**SPECIAL SERVICE INSTRUCTION**

**SSI10-5**

**SUBJECT:** Part 1; Sump inspection and Oil Gage Rod replacement O200D1B S/N as listed.  
Part 2; Inspection for machining material, all O200D1B and D2B

**PURPOSE:** Part 1; To remove potential of Oil Gage Rod tip chafing the oil sump wall.  
Part 2: To inspect for and remove any machining debris from the engine

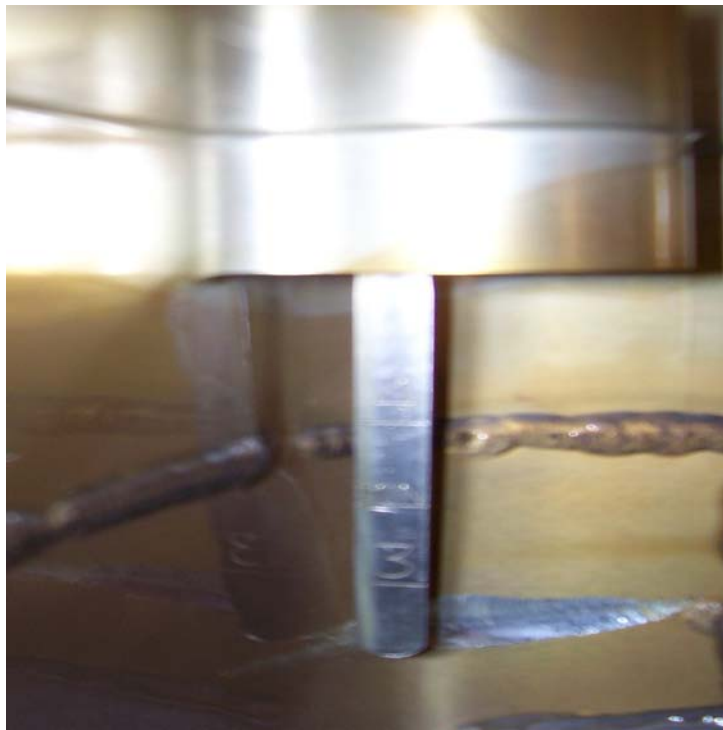
Inspected engines may continue in use, pending a replacement of the oil gage rod. The original oil gage rod, part number 657474-1, is to be temporarily replaced with a modified oil gage rod part number 657474-1-M. This oil gage rod (plug) is shortened and cannot contact the oil sump.

**The original oil gage rod must be removed and kept stored in the aircraft in a suitable protective container to allow access for use during preflight or post flight inspections and oil level servicing until a replacement oil gage rod is installed.**

After each preflight, post flight or oil level check, the original oil gage rod is to be removed from the engine and returned to its suitable protective container in the aircraft prior to starting the engine. The modified oil gage rod (plug) must be installed for all ground and flight operation of the engine.

**DO NOT OPERATE THE ENGINE OR AIRCRAFT WITH THE ORIGINAL 657474-1 OIL GAGE ROD INSTALLED IN THE OIL SUMP OF THE ENGINE. ENGINE IS TO BE OPERATED ONLY WITH THE MODIFIED OIL GAGE ROD (PLUG) 657474-1-M INSTALLED UNTIL SUCH TIME THAT A NEW REPLACEMENT OIL GAGE ROD IS OBTAINED FROM CESSNA AND INSTALLED IN THE ENGINE**
